February 18, 2022

ADDENDUM NUMBER ONE (1)

- Project: Walter Washington Roof Replacement Utica Campus DA PN: 21111 (Hinds Bid # 3241)
- FROM: Dean Architecture, P.A. 661 Sunnybrook Road, Suite 140 Ridgeland, MS 39157 (601) 939-7717

ROOF PLAN / NOTES

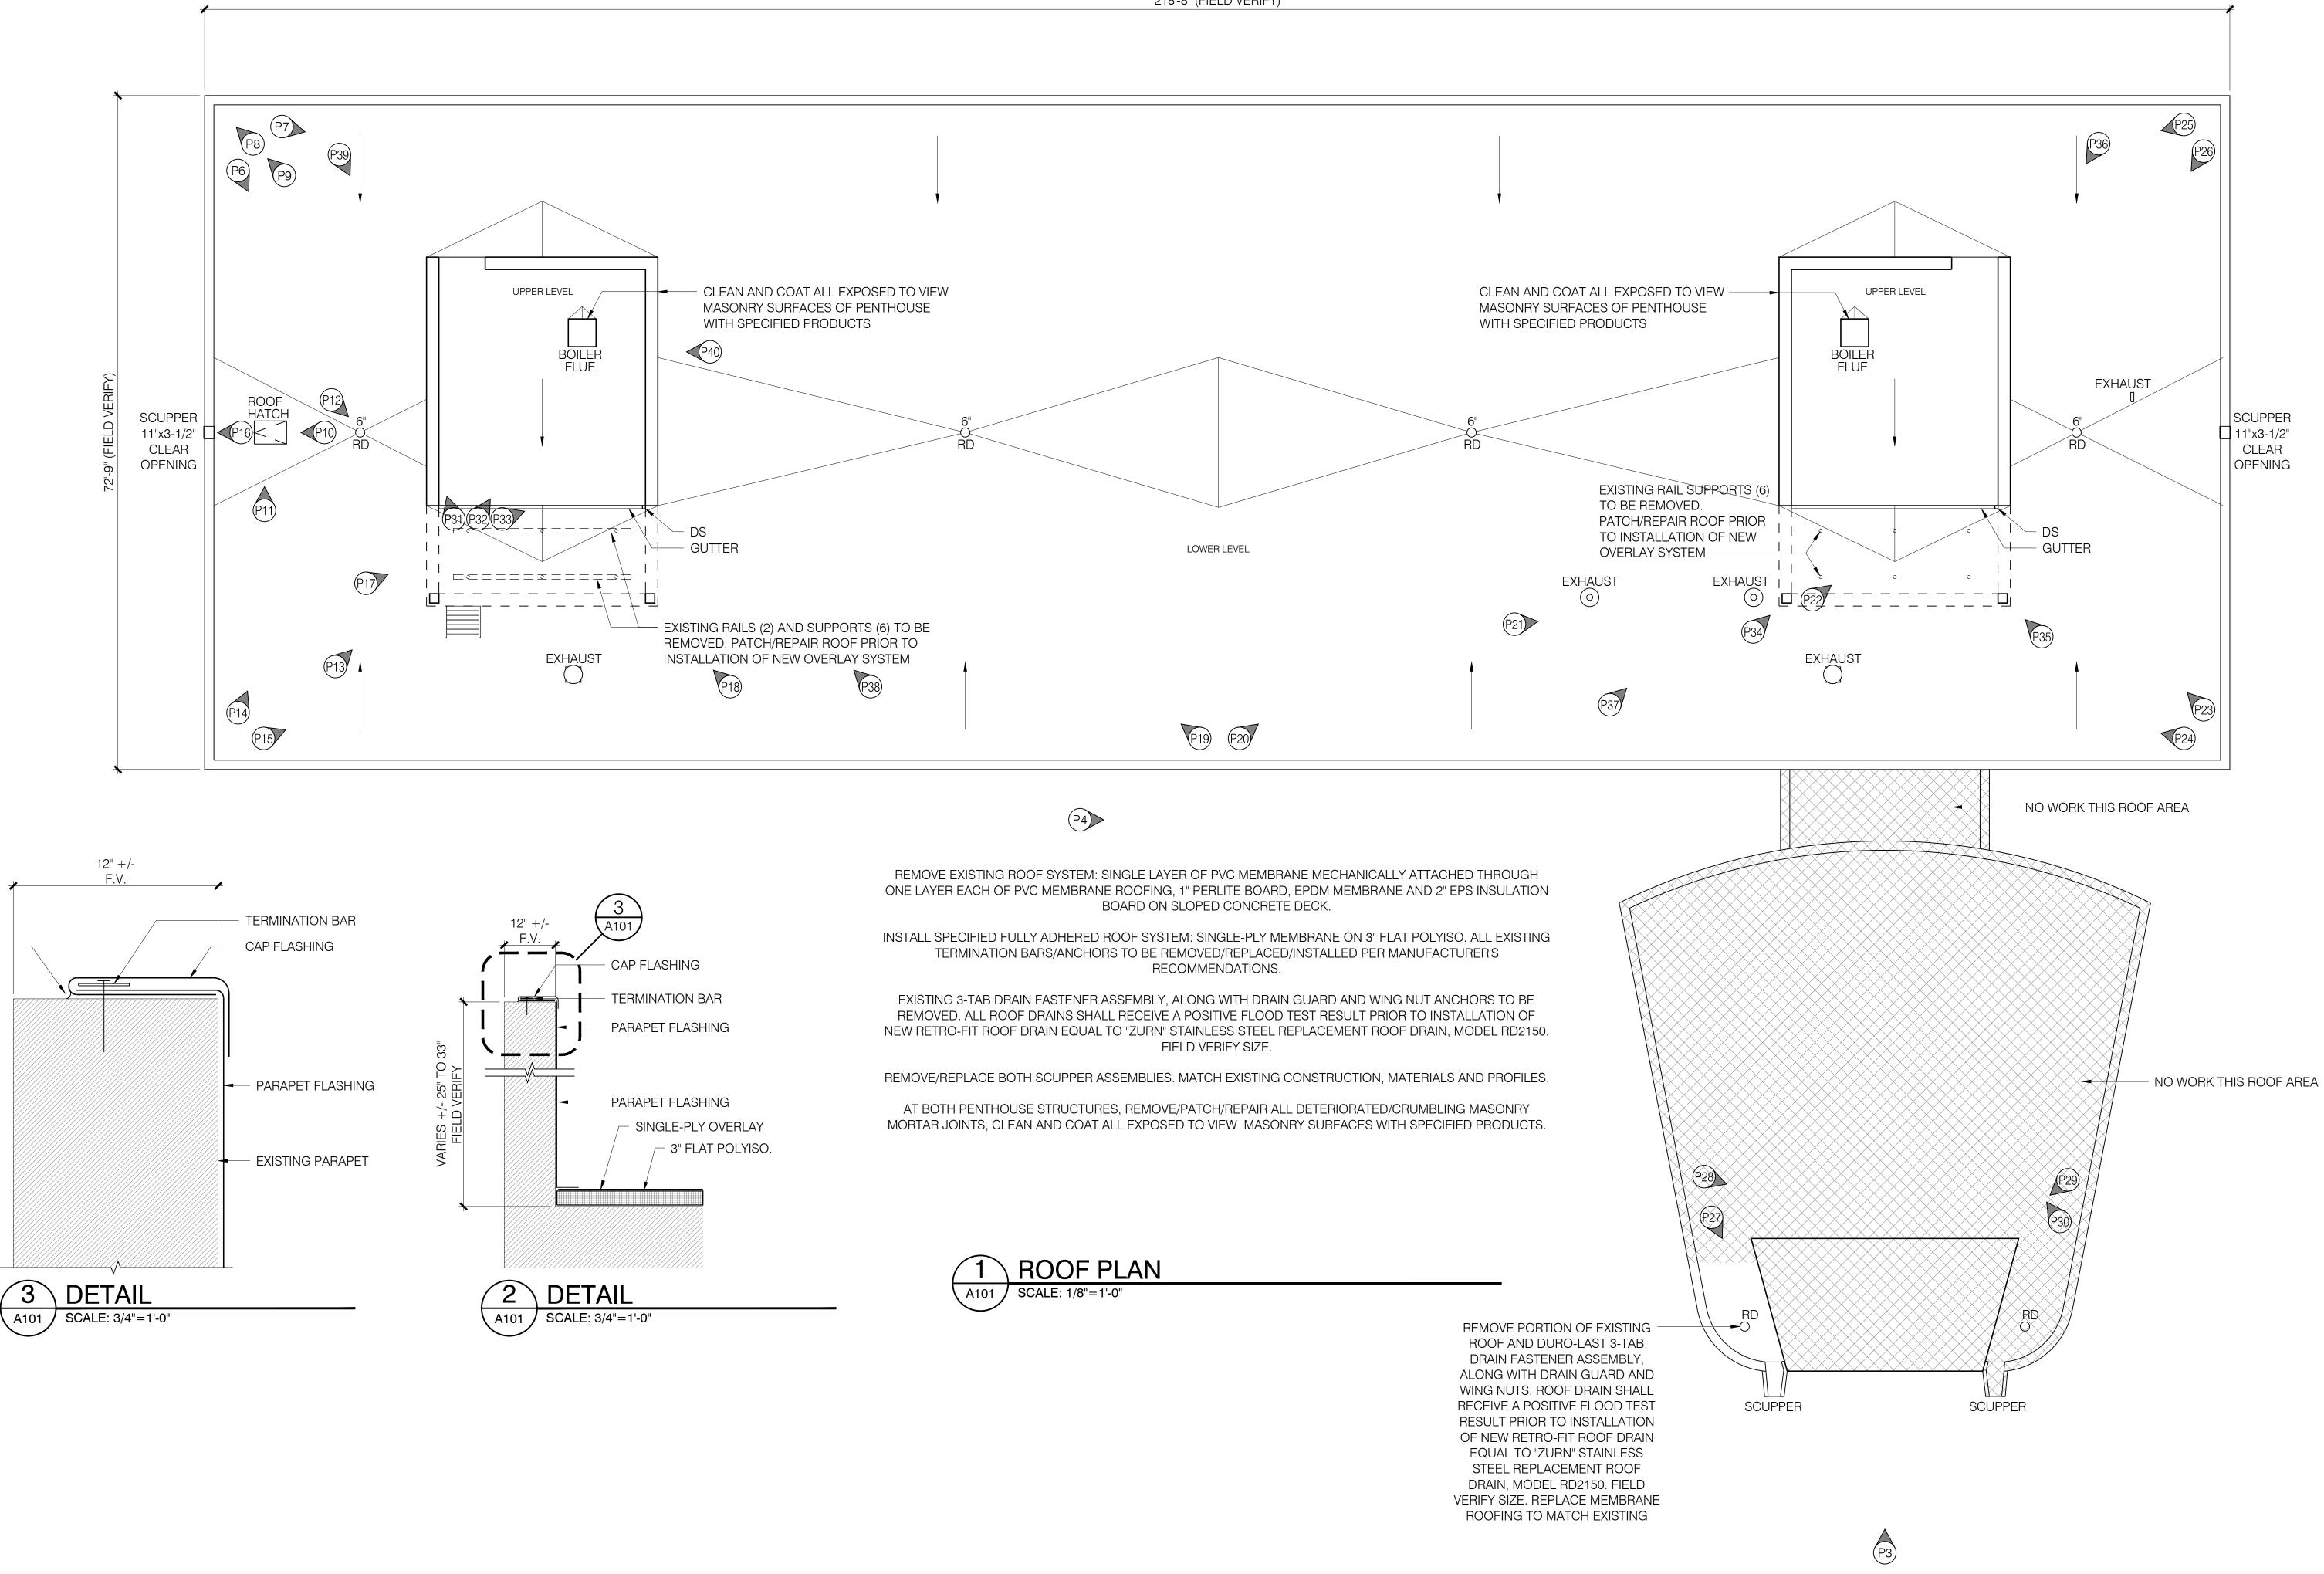
Item #1: Remove existing Drawing Sheet A101 Roof Plan / Notes and replace with the revised Sheet A101 Roof Plan / Notes dated Feb 18, 2022 – Revised to remove existing roof system in its entirety and replace with new roof system.
